Technical Service Bulletin

CHECK ENGINE LIGHT ON WITH DTC P2096:00

Bulletin No.: 01-011/19

Last Issued: 04/15/2019

PCM Identification

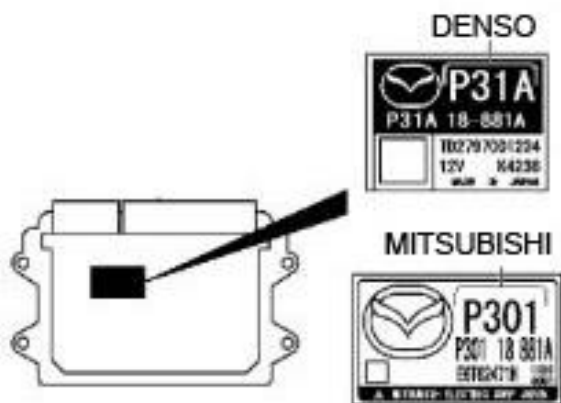
NOTE: This concern occurs only on vehicles with PCMs manufactured by Mitsubishi.

Due to improper control logic of the PCM, a false error may be detected. To eliminate this concern, the PCM software has been modified.

1. Verify the customer concern.
2. Using the image above, verify the PCM is manufactured by Mitsubishi.
3. Reboot the IDS to clear memory before reprogramming.
4. Using IDS **113.01** or later software, reprogram the PCM to the latest calibration (refer to "Calibration Information" table) by following the "Module Reprogramming" procedure.
